PUBLIC NOTICE

PP-21-05

CASE SUMMARY

CASE NUMBER: PP-21-05

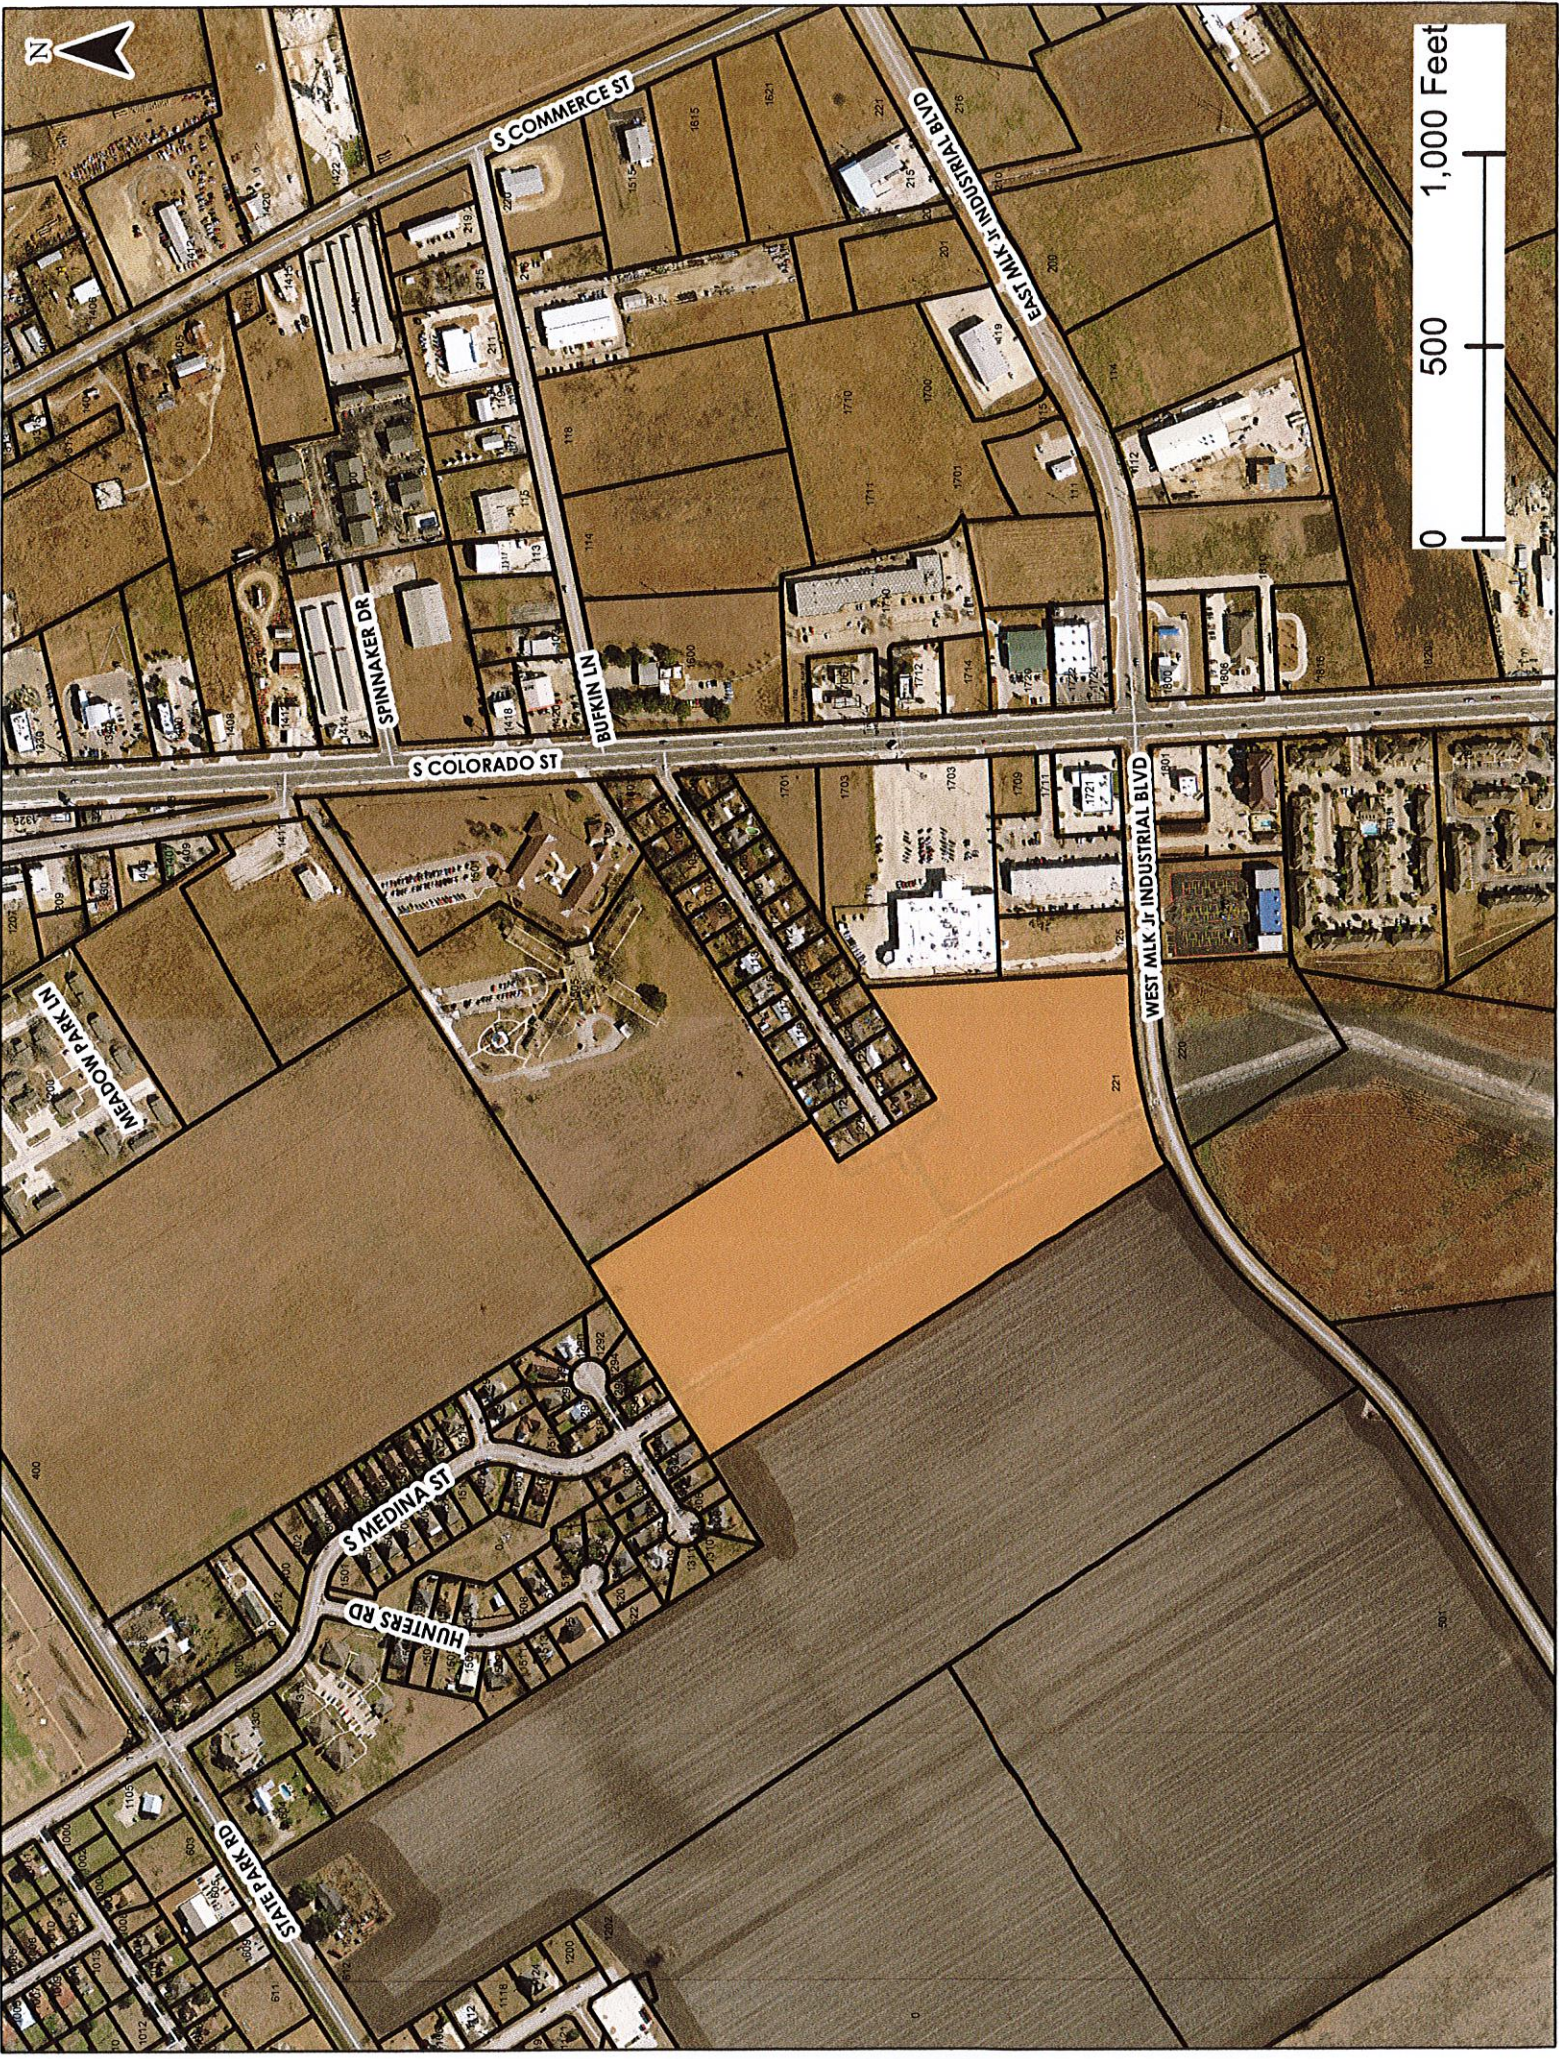
SUGGESTED CONDITIONS: Change the 20-foot front building setback shown for both proposed commercial lots to 25 feet, and delete the reference to commercial zoning front setback in Note #8.

CONCURRENT VARIANCE REQUESTED: A Variance is requested to the requirement in Section 52-72(a) that Sunset Drive conform to Thoroughfare Plan designation of Sunset Drive as a Collector Street. As provided in Section 52-72(i)(2), the minimum right-of-way width for collector streets is 60 feet, whereas the applicant proposes a 50-foot width, which matches the right-of-way width of the existing Sunset Drive. The applicant's justification is explained in the attached letter dated September 10th from the applicant's engineer.

The right of way width for this extension of Sunset Drive is required to be 60 feet wide due to its designation as a collector street. A variance is requested to provide a 50 foot wide right of way width for Sunset Drive, east of the proposed Golden Parkway.

We will proceed with the understanding that 25 foot street setbacks are required by the zoning criteria and being fully transparent with staff and commissioners, may elect to request this variance in the future as the commercial lots are developed.
